# **MEMO**

**Subject:** Review of Water Right Application G-18914

# **Groundwater Application Review Summary Form**

Application # G- 18914 GW Reviewer M. Thoma Date Review Completed: 08/06/2020 **Summary of GW Availability and Injury Review:** ☐ Groundwater for the proposed use is either over appropriated, will not likely be available in the amounts requested without injury to prior water rights, OR will not likely be available within the capacity of the groundwater resource per Section B of the attached review form. **Summary of Potential for Substantial Interference Review:** There is the potential for substantial interference per Section C of the attached review form. **Summary of Well Construction Assessment:** The well does not appear to meet current well construction standards per Section D of the attached review form. Route through Well Construction and Compliance Section. This is only a summary. Documentation is attached and should be read thoroughly to understand the basis for determinations and for conditions that may be necessary for a permit (if one is issued).

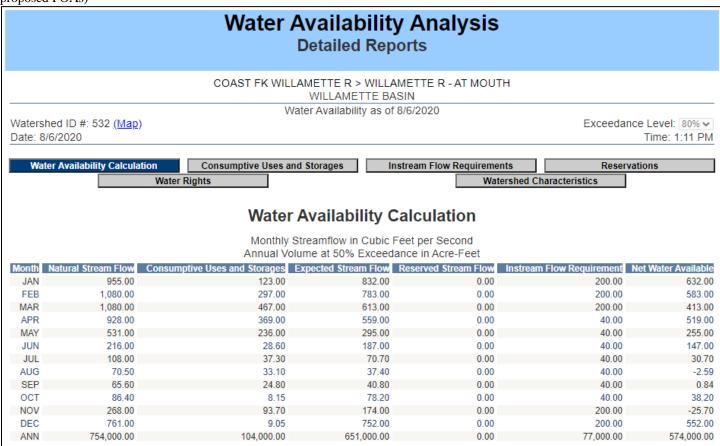
**Comments:** Stream-depletion was estimated using the Hunt-2003 stream-depletion model with hydraulic parameters within a range of values likely for the aquifer systems in the area.

<sup>\*</sup>There are two instream rights on the Coast Fork Willamette River WAB: MF532 has lower required flows but extends only 1 mile above the confluence and not to the reach adjacent to the applicant's proposed POA. IS81887 covers the reach adjacent to the proposed POAs and so was evaluated in Table C3a

#### **Interference Model Results**

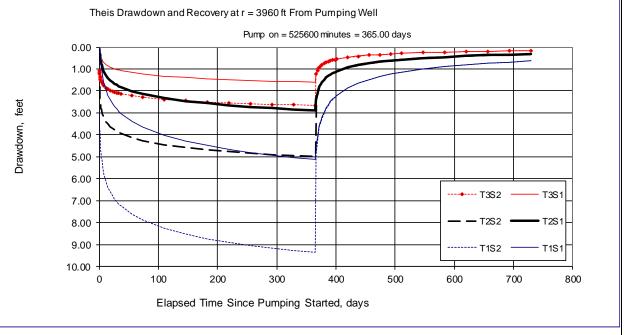
d.	☐ <b>Well reconstruction</b> is necessary to accomplish one or more of the above conditions. The problems that are likely to occur with this use and without reconstructing are cited below. Without reconstruction, I recommend withholding issuance of the permit until evidence of well reconstruction is filed with the Department and approved by the Groundwater Section.
		<b>Describe injury</b> —as related to water availability— that is likely to occur without well reconstruction (interference w/senior water rights, not within the capacity of the resource, etc):
В3.	tern	bundwater availability remarks: There is little water level data in the immediate area of the proposed POA so long- n trends cannot be identified. Additionally, a rigorous analysis of the water-balance for the aquifer system in the area has been performed and so Over-Appropriation cannot be determined.
	rang	nearest permitted groundwater right is approximately ¾ of a mile from the proposed POAs. At this distance and given a ge of likely hydraulic parameter values, interference at the existing permitted POAs is likely to be only a few feet and thus likely to cause injury. However, standard interreference conditions shall apply.
